ADDENDUM NO. 5

**CONTRACT RFB-RC-SWR-CIP 2020-02
MAIN PUMP STATION UPGRADE PROJECT**

**ROCKLAND COUNTY SEWER DISTRICT NO. 1
ROCKLAND COUNTY, NEW YORK**

September 8, 2021

AERATED GRIT CHAMBER
PLAN - EL. 78.0'

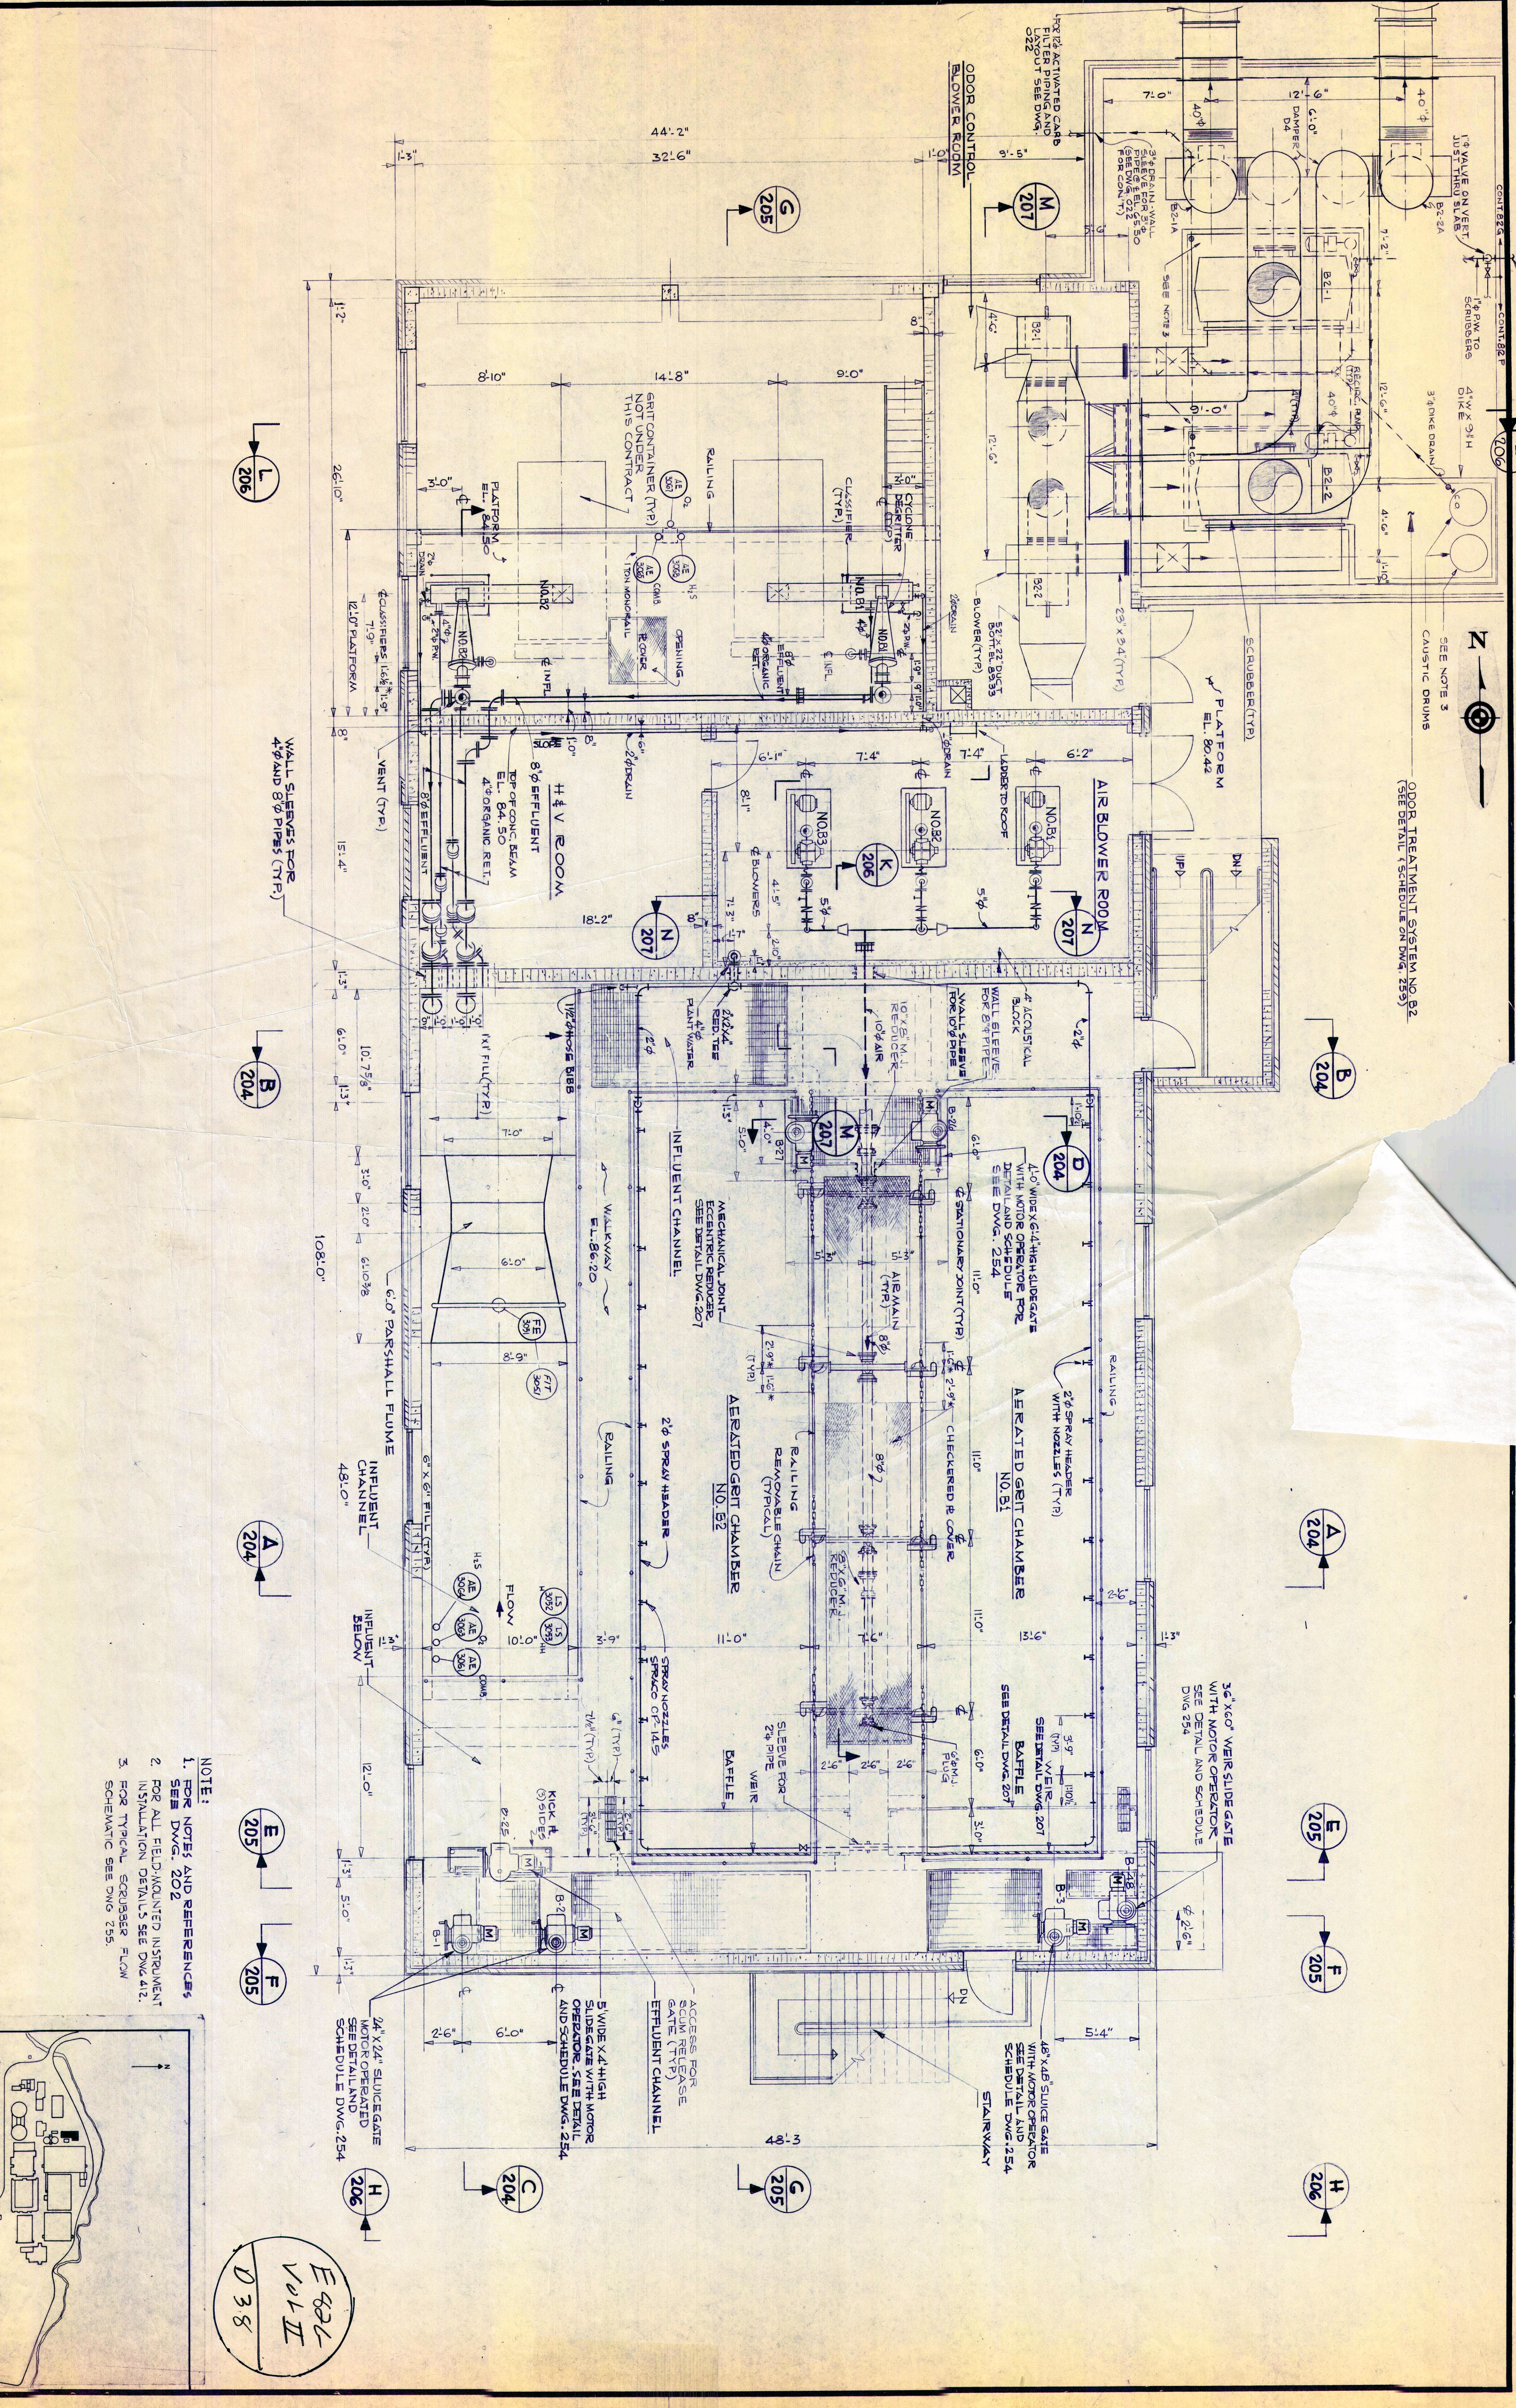
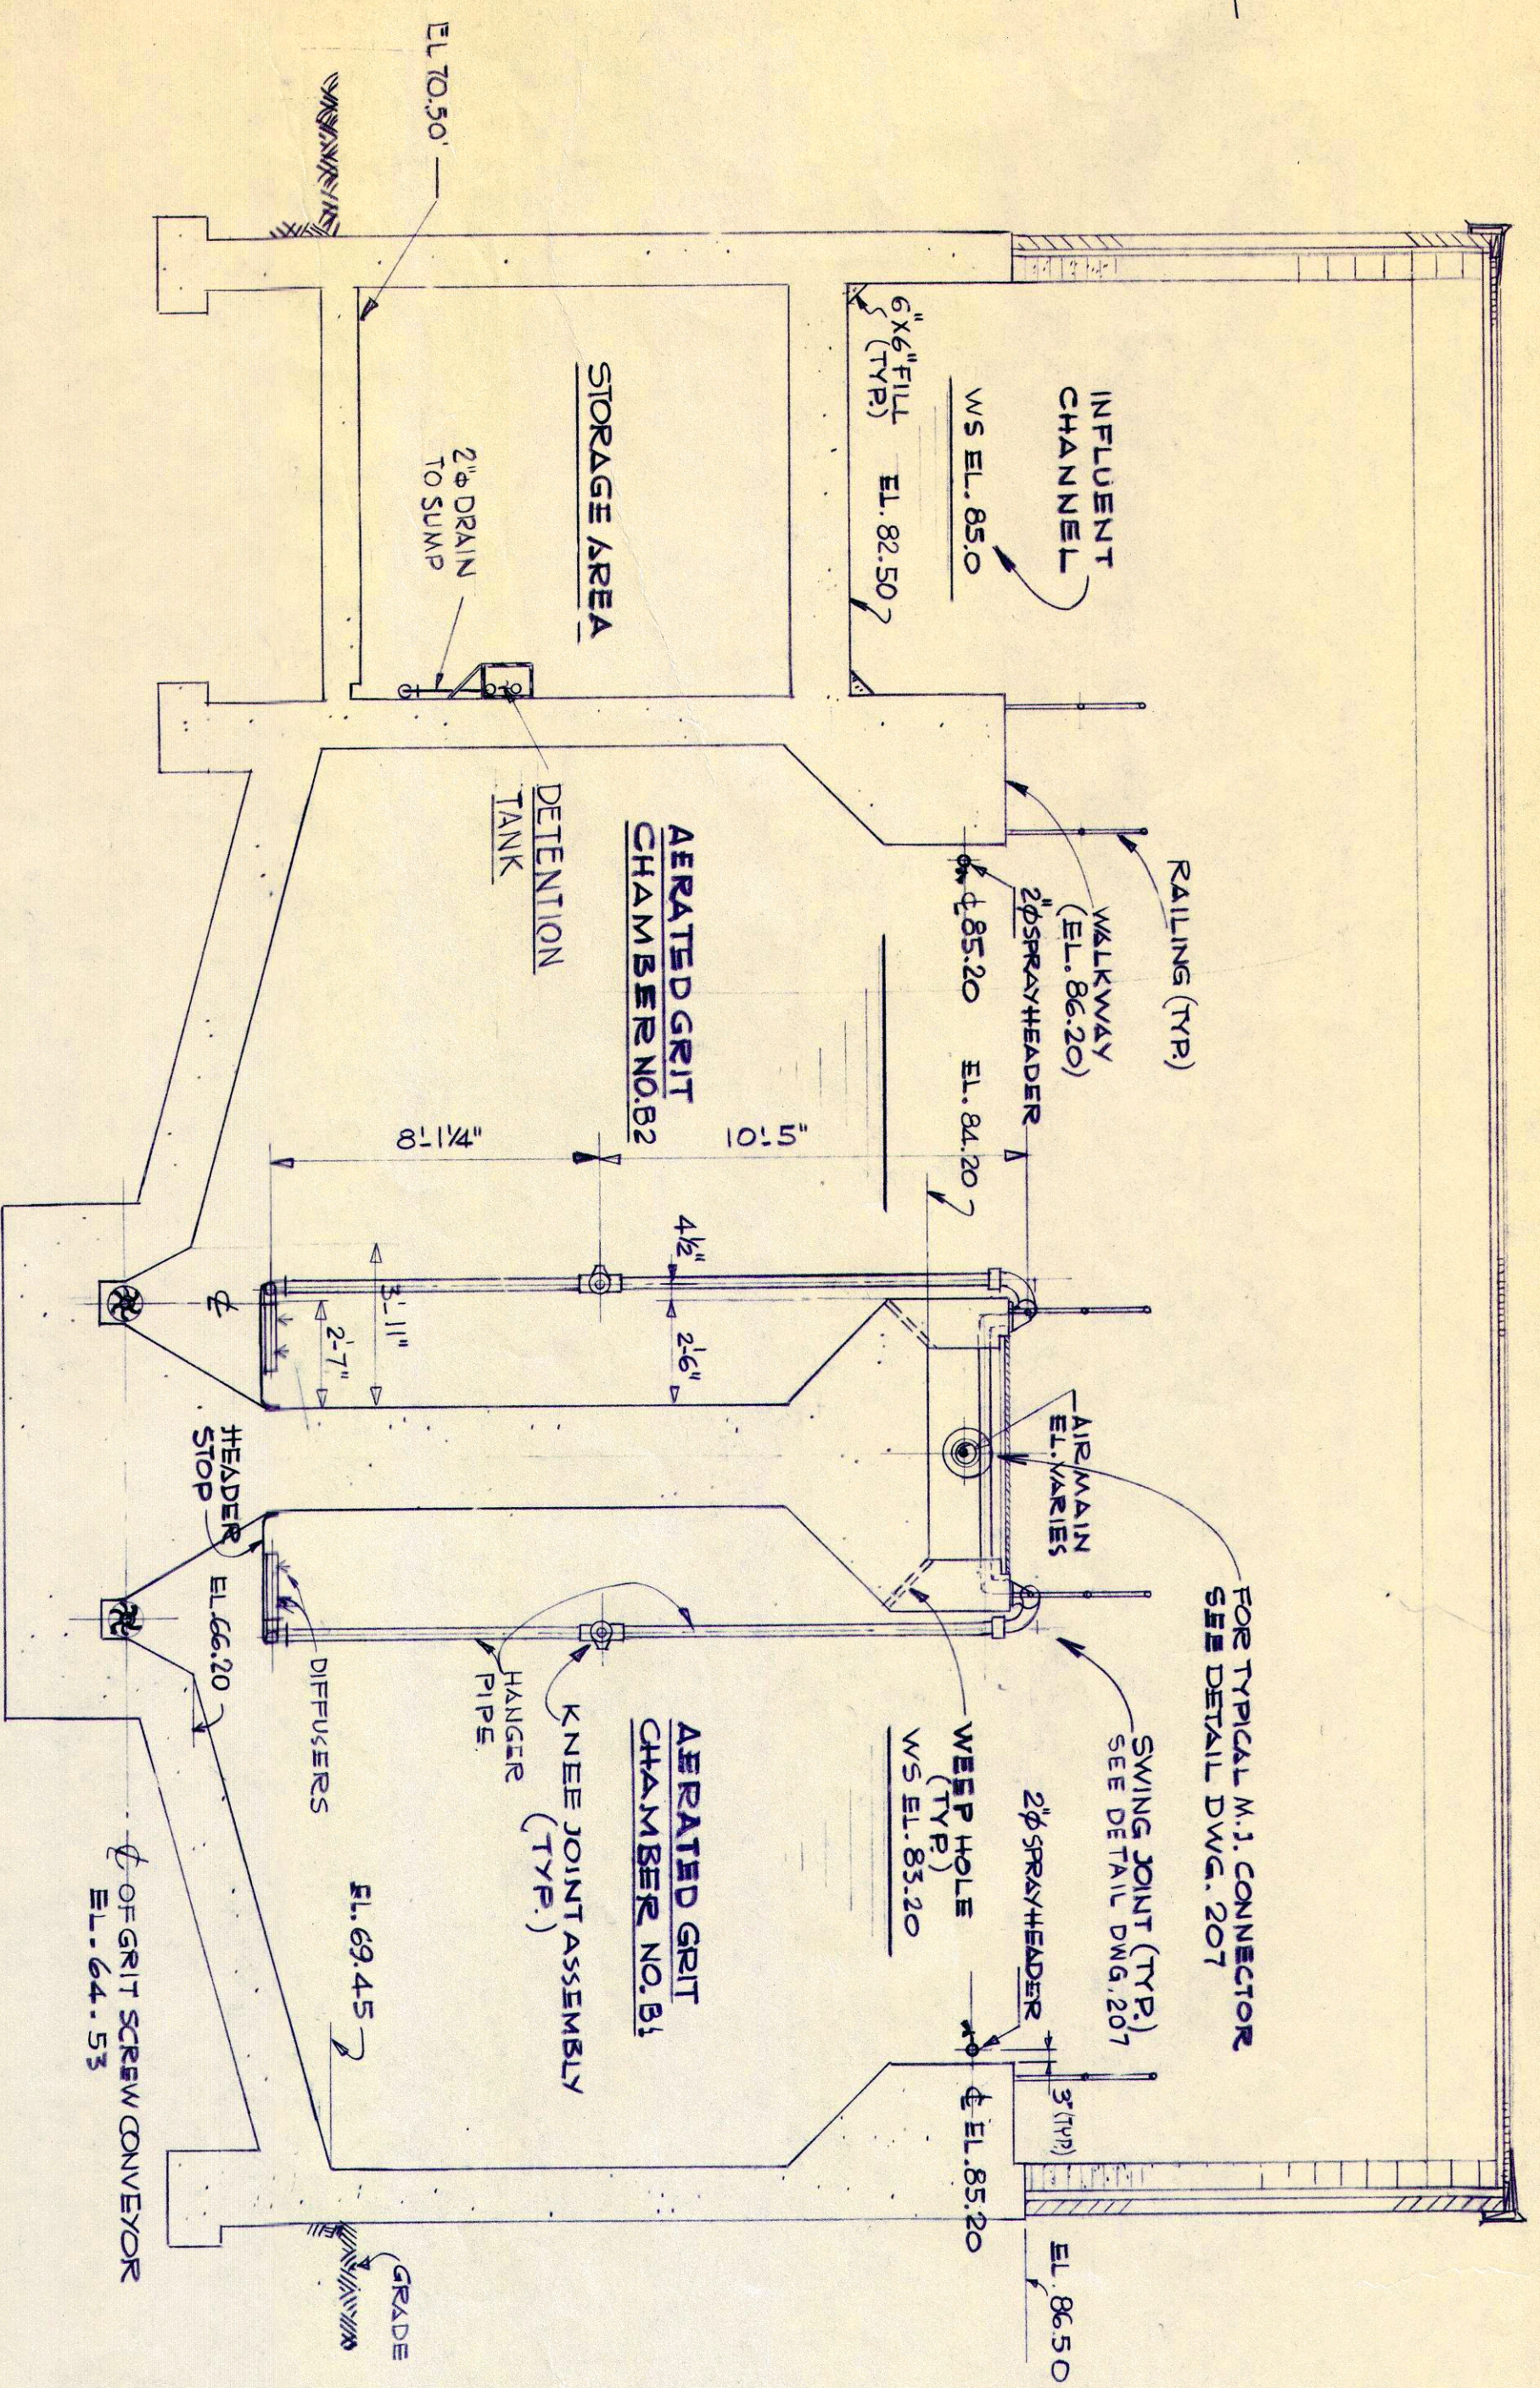
From the additional drawings provided in Addendum #2, we are unable to determine the following information related to the Grit Tanks Influent Channel upstream of the Parshall Flume in the Grit Building:

- a. Channel width
- b. Channel depth
- c. Normal water depth

Please provide this information as it is necessary in order to determine the bulkhead required during bypass operations.

See Attachment 2 - Contract 82 Vol II Drawings. Water depth is dependent of flow from the main pump station.
